**New York Power  
Authority**

**Improved Technical Specifications  
Conversion Submittal**

**INDIAN POINT 3**

SECTION I:  
APPLICATION OF THE  
NRC FINAL POLICY STATEMENT  
SELECTION CRITERIA TO THE  
INDIAN POINT NUCLEAR GENERATING UNIT NO. 3  
TECHNICAL SPECIFICATIONS

# Relocated Item (R-7)

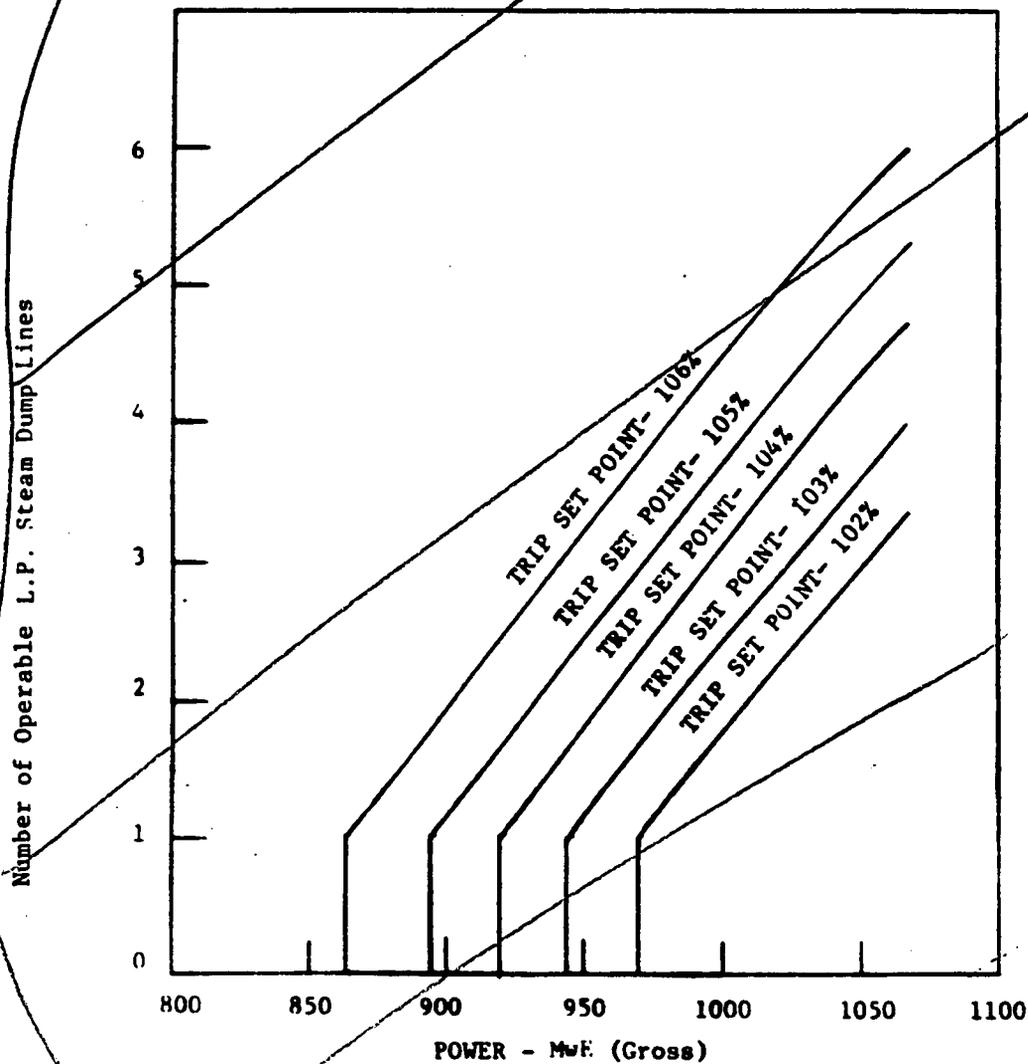
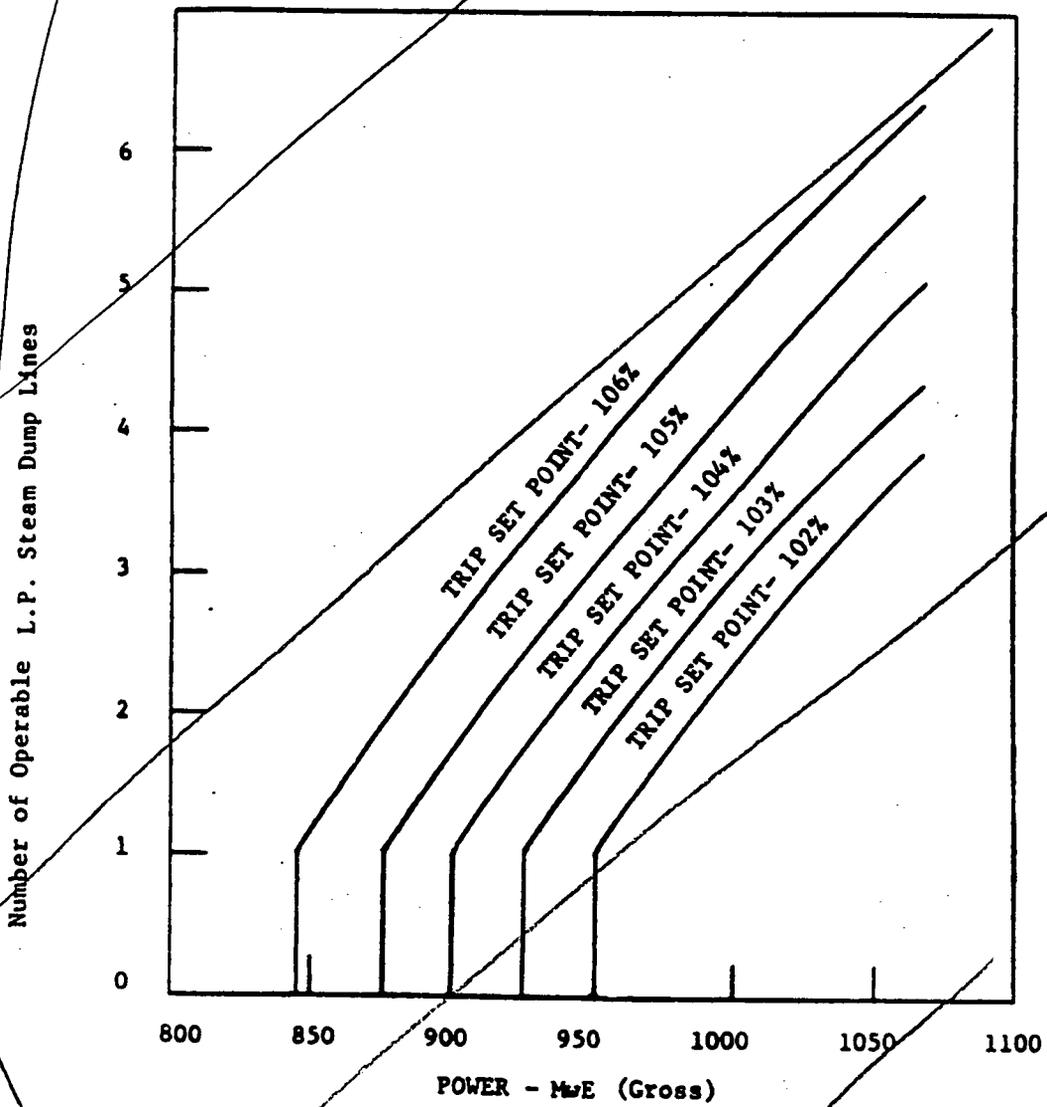
D. The gross turbine-generator electrical output at all times shall be within the limitation of Figure 3.4-1 or Figure 3.4-2 for the application conditions of turbine overspeed setpoint, number of operable low pressure steam dump lines, and condenser back pressure as noted thereon. R.7

The limitations placed on turbine-generator electrical output due to conditions of turbine overspeed setpoint, number of operable steam dump lines, and condenser back pressure are established to assure that turbine overspeed (during conditions of loss of plant load) will be within the design overspeed value considered in the turbine missile analysis. <sup>(2)</sup> In the preparation of Figures 3.4-1 and 3.4-2, the specified number of operable L.P. steam dump lines is shown as one (1) greater than the minimum number required to act during a plant trip. The limitations on electrical output, as indicated in Figures 3.4-1 and 3.4-2, thus consider the required performance of the L.P. Steam Dump System in the event of a single failure for any given number of operable dump lines.

FIGURE 2.1-1

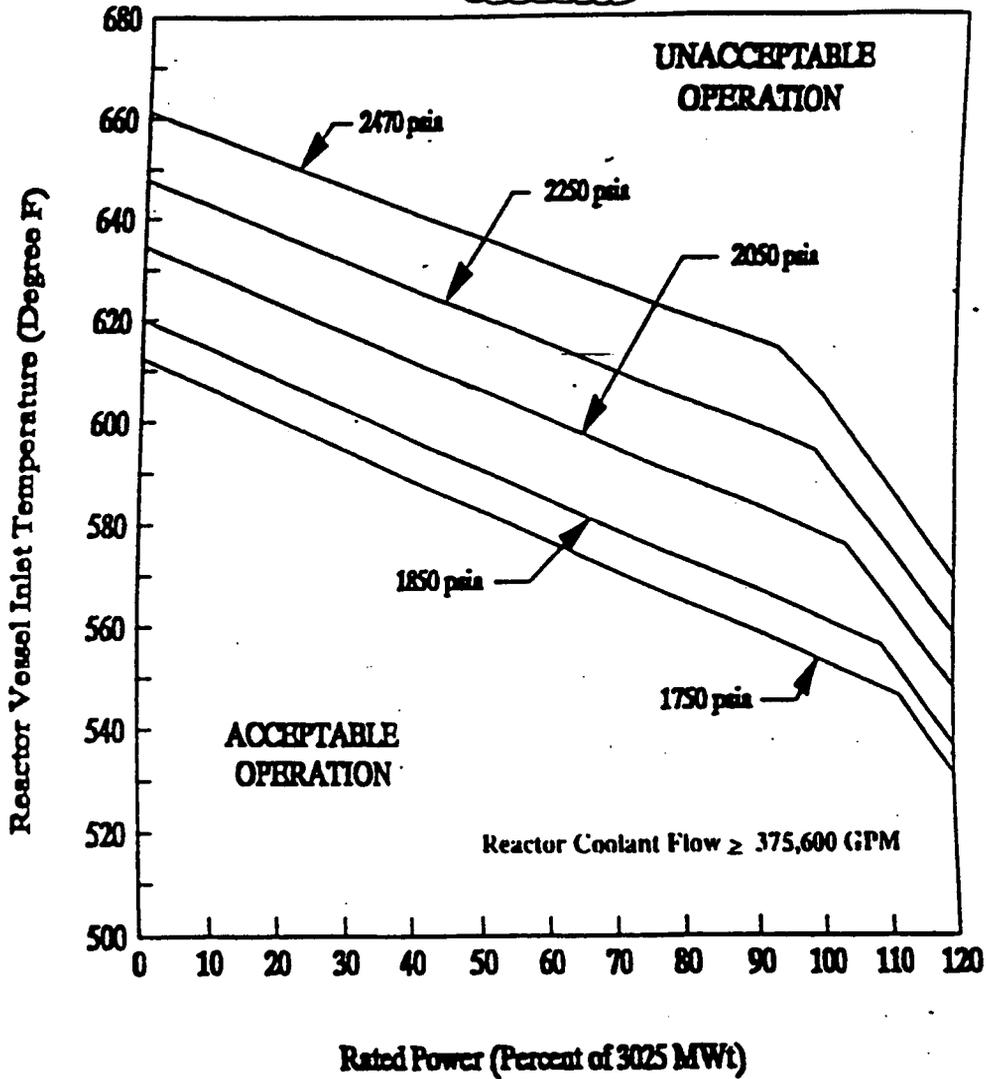
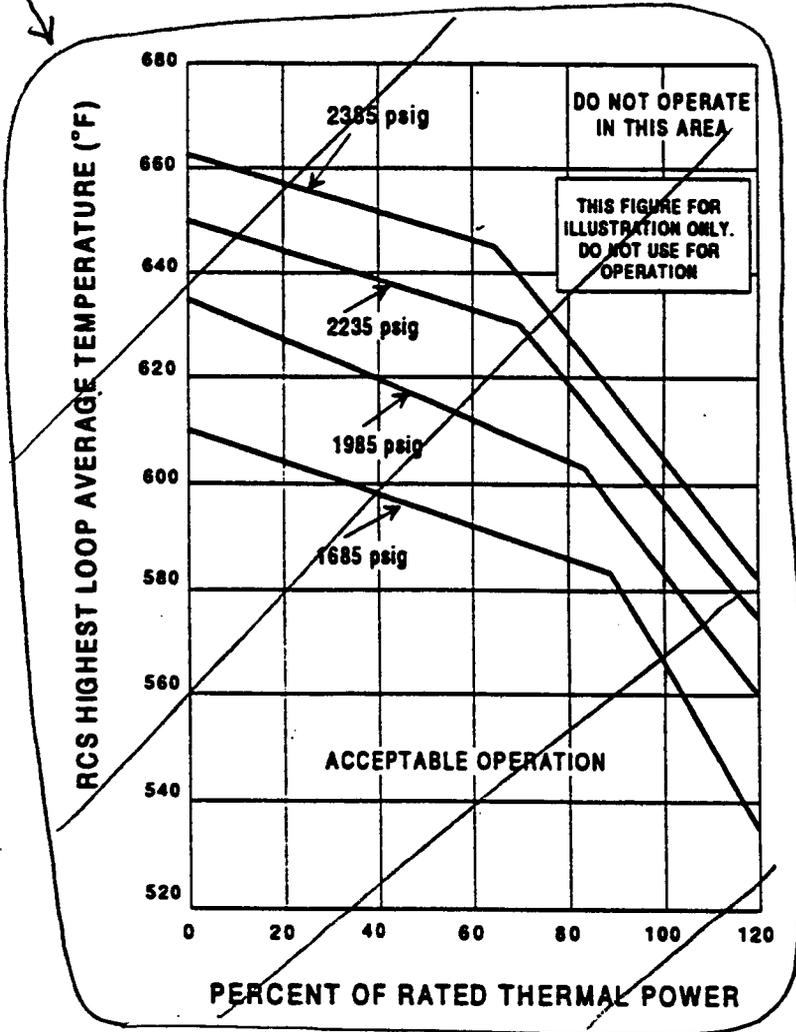
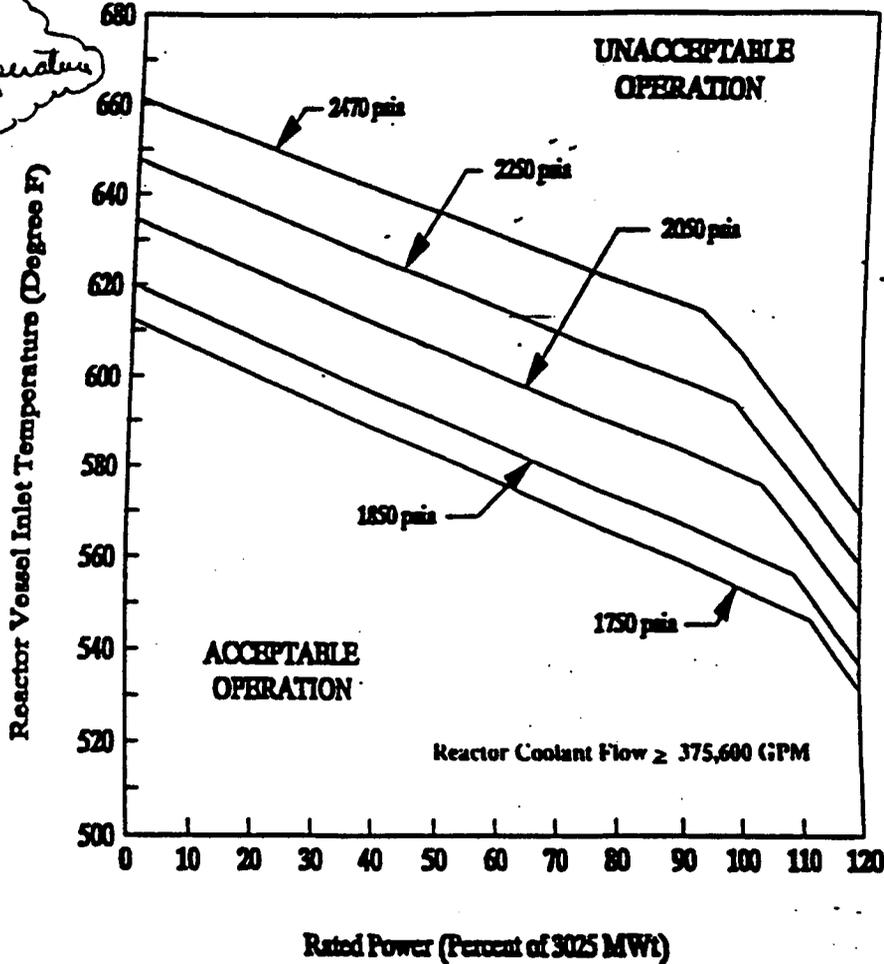
- A.3 CTS 2.1 establishes a safety limit that the combination of thermal power, coolant pressure, and coolant temperature must not exceed the limits for four-loop operation shown in CTS Figure 2.1-1.

ITS 2.1.1 in conjunction with ITS Figure 2.1.1-1 maintains the same safety limit as CTS 2.1; however, ITS 2.1.1 is more specific than CTS 2.1 and specifies that the safety limits are based on pressurizer

Figure 3.1.7 (page 1 of 1)  
Moderator Temperature Coefficient vs. Power Level

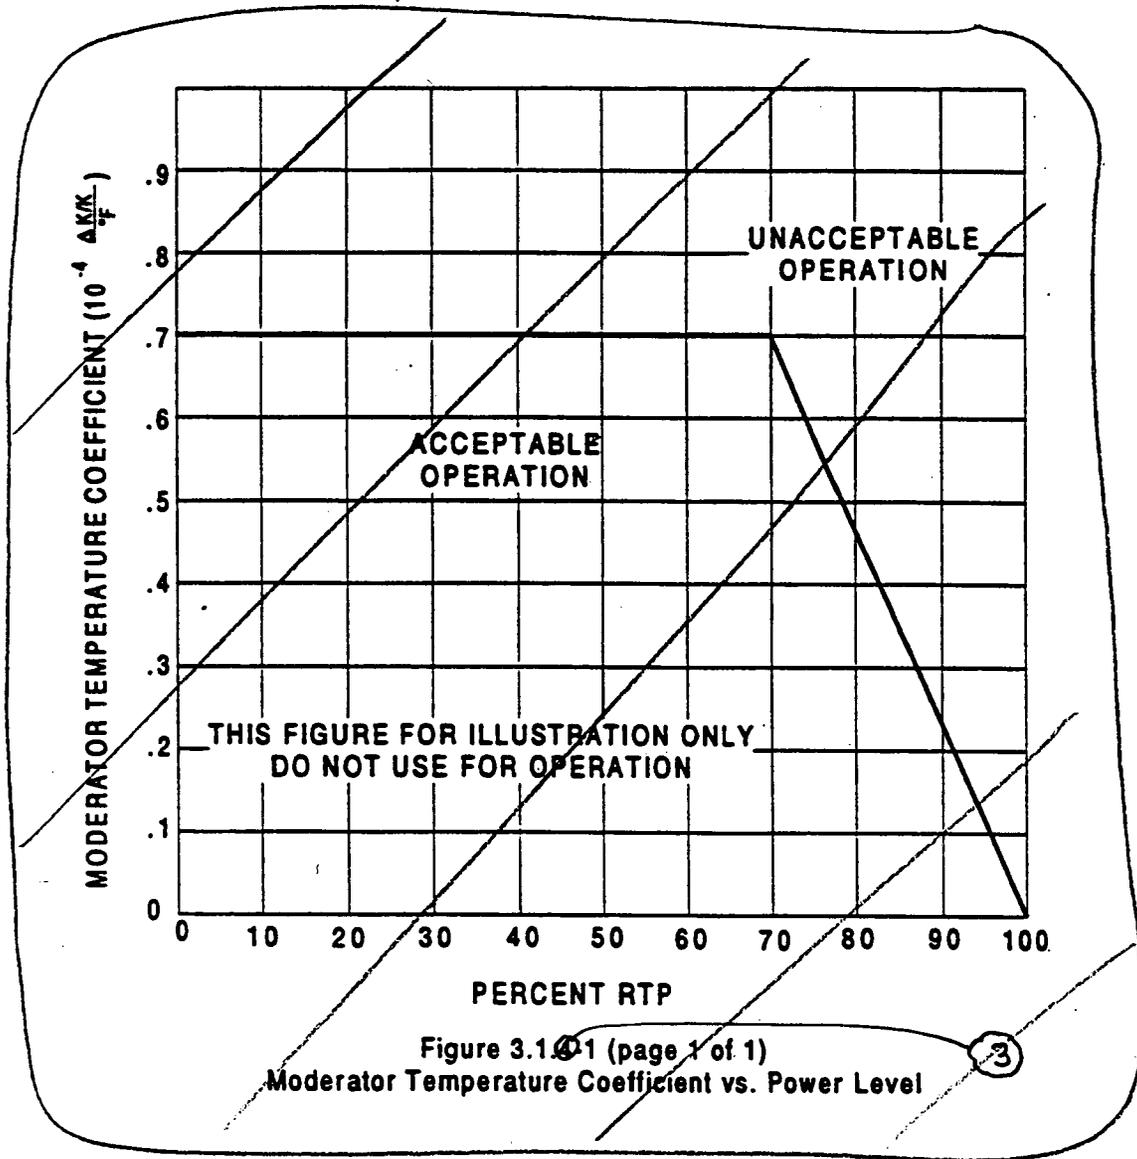
The MTC shall be maintained within the limits specified in the COLR. The maximum upper limit shall be  $\leq$    $\Delta k/k^{\circ}F$  at hot zero power, ~~that specified in Figure 3.1.4/1.~~

*delete page*

Figure B 3.2.1B-1 (page 1 of 1)  
K(Z) - Normalized F<sub>e</sub>(Z) as a Function of Core Height

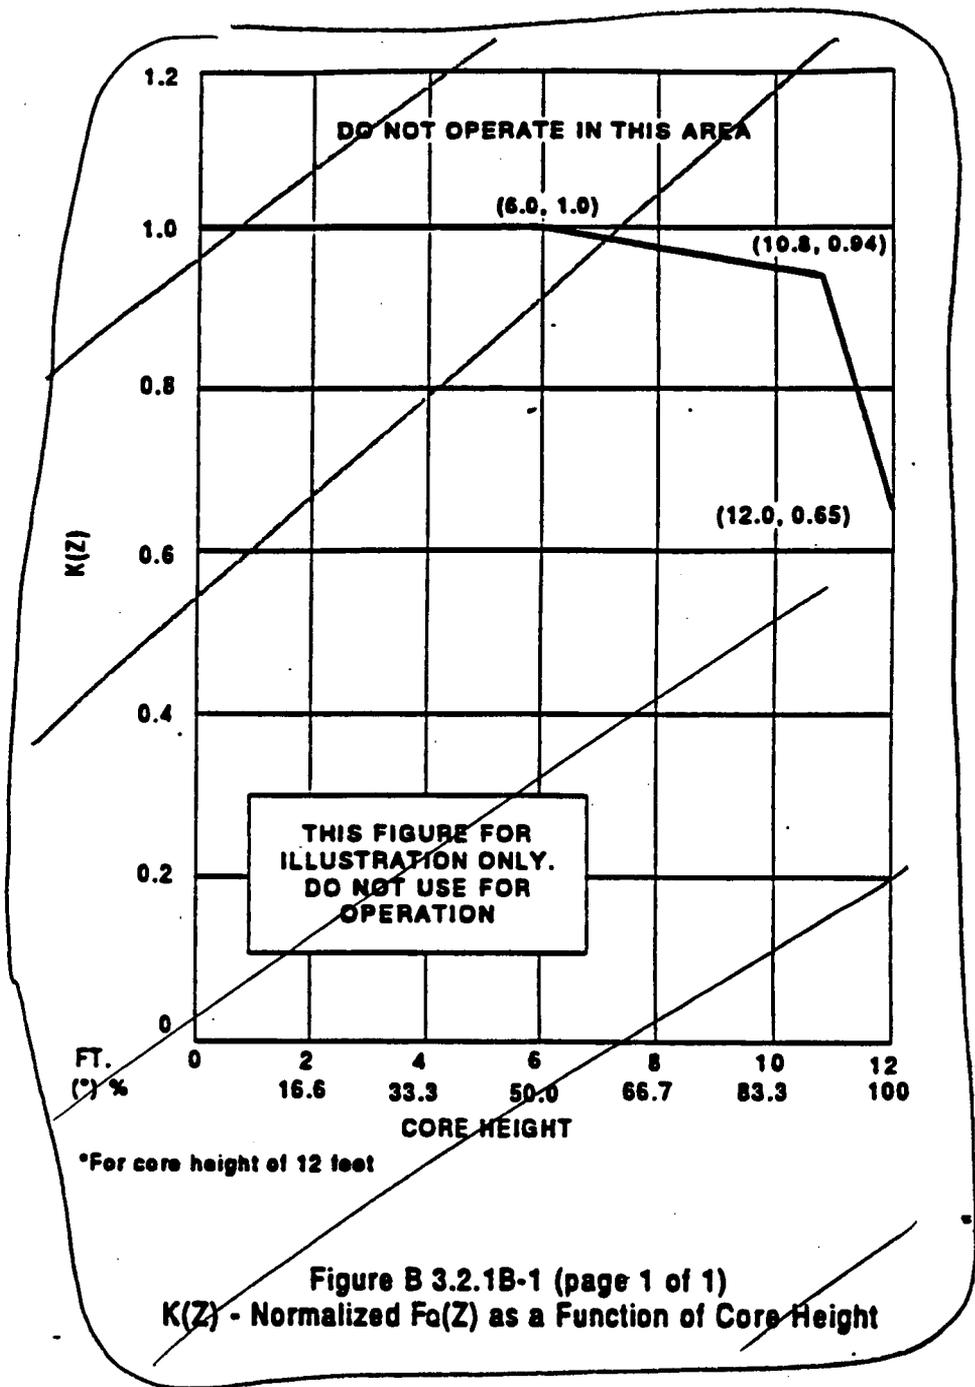
- X.1 NUREG-1431, Rev 1, Section 3.2.1, was modified to delete Figure B 3.2.1B-1 because IP3 maintains the Heat Flux Hot Channel Factor ( $F_Q(Z)$ ) limits in the Core Operating Limits Report.
